Second Correlating Revision No. 129-NFPA 70-2025 [Global Input]

Second Correlating Revision No. 139-NFPA 70-2025 [Global Input]

Figure 90.3 Code Arrangement.

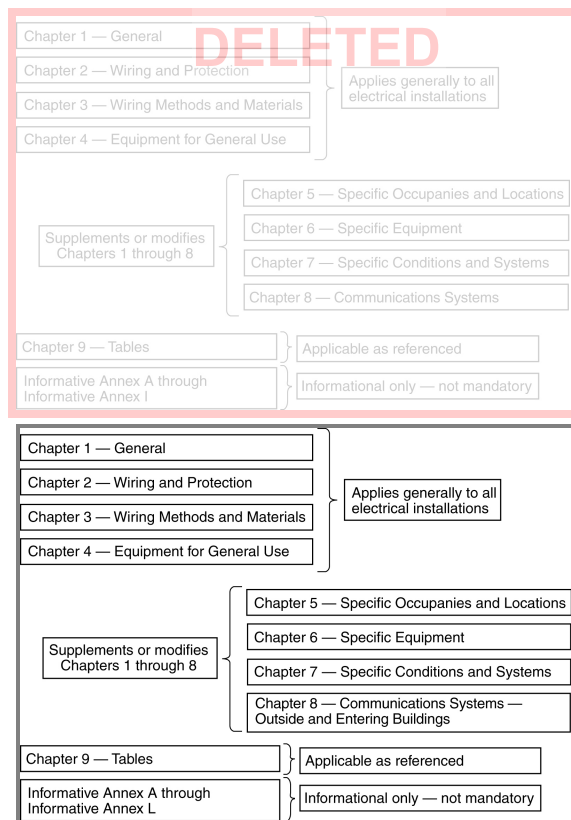
This revision is for correlation with the change of the title of Chapter 8. Additionally, the titles of the chapters in the table of contents are to be revised to align with Figure 90.3.

**Figure Informational Note
708.54 Critical Operations Power
System Selective Coordination.**

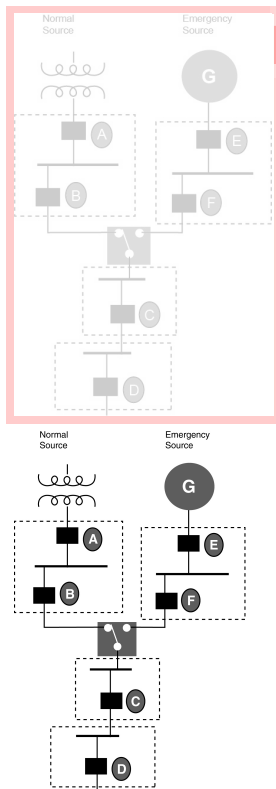
Informational Note: See Figure Informational Note 708.54 for an example of how critical operations power system OCPDs selectively coordinate with all supply-side OCPDs.

~~OCPD F selectively coordinates with OCPD E.~~

~~OCPD B is not required to selectively coordinate with OCPD A because OCPD B is not a critical operations power system OCPD.~~

DELETED
